Council of the Isles of Scilly Delegated Planning Report Householder application

Application Number: P/25/091/HH

Site Address:
Atlantic View
High Lanes
St Mary's
Isles Of Scilly
TR21 0NW

Proposal: Re-modeling of existing house and extension for garage and utility room (AMENDED PLANS)

Front Elevation

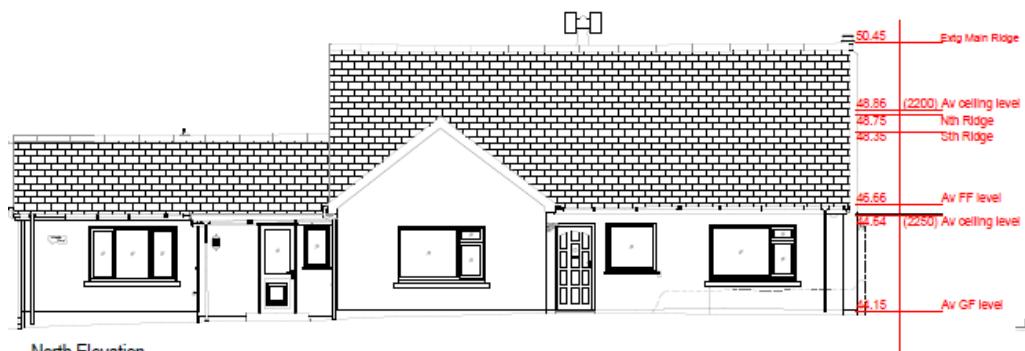
- Removal of the north-elevation dormer, replaced with a flush rooflight that sits low within the roof slope, markedly reducing prominence.
- Redesign of the south-elevation dormer, with a lower flat roof replacing the previous pitched form, reducing bulk and horizontality.
- Removal of the pitched feature over the right-hand first-floor window, simplifying the roofscape.
- Demolition of existing extensions, shown by hatching on the submitted plans, which offsets new built form and helps ensure the total mass is no greater than that currently present.
- A limited ridge-height increase of 300 mm, justified as necessary for modern insulation and thermal detailing under current Building Regulations.
